CITY OF ALBUQUERQUE

**RE: 4417 Hidden Valley Court NE
Revised Grading and Drainage Plan
Engineer's Stamp Date: 11/129/19
Engineer's Certification Date: 11/12/19
Hydrology File: G23D014**

DRAINAGE AND TRANSPORTATION INFORMATION SHEET (REV 6/2018)

ENGINEER'S SEAL	LOT 107, BK 15 UN 3 GLENWOOD HILLS SUB HIDDEN VALLEY COURT	DRAWN BY DEM
	GRADING AND DRAINAGE PLAN	DATE 4-22-19
DAVID SOULE P.E. #14522	1606 CENTRAL AVENUE SE SUITE 201 ALBUQUERQUE, NM 87108 (505) 872-0999	LOT 107 BLK 15 UN 3 GLENWOOD HILLS.DWG
		SHEET # C1
		JOB #

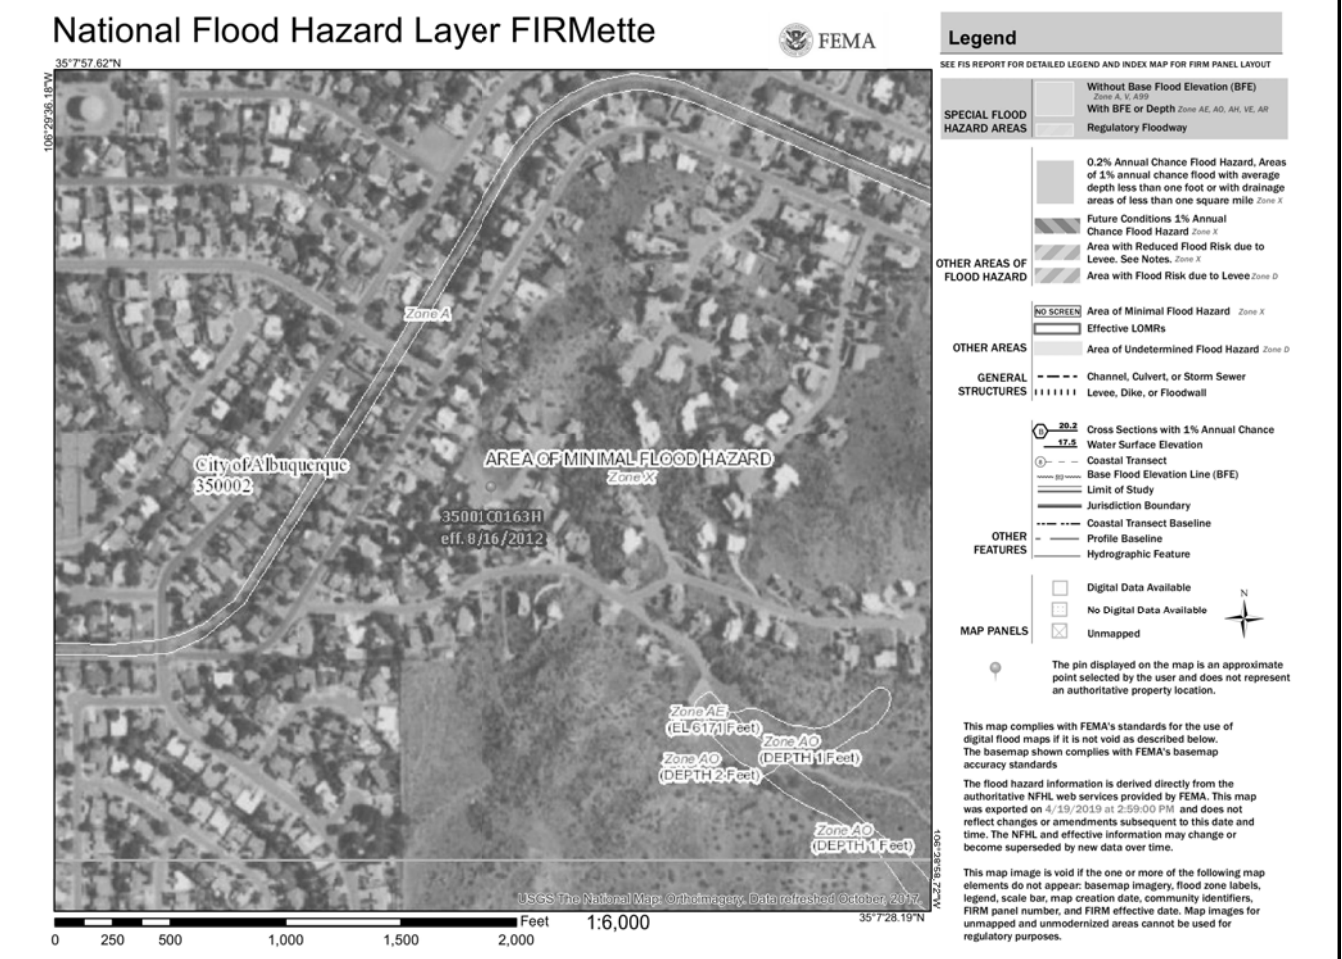
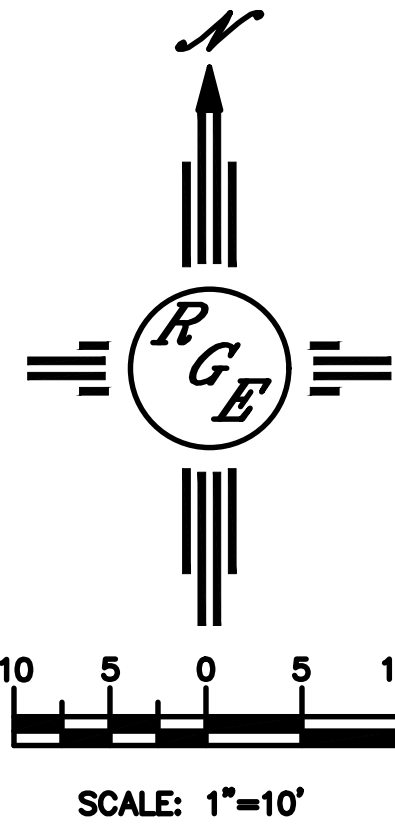
Based upon the information provided in your submittal received 11/13/19, the Revised Grading and Drainage Plan are approved for Building Permit and Building Pad Certification for 4417 Hidden Valley Court NE. Please attach a copy of this approved plan in the construction sets for Building Permit processing along with a copy of this letter.

Prior to approval in support of Permanent Release of Occupancy by Hydrology, Engineer Certification per the DPM checklist will be required.
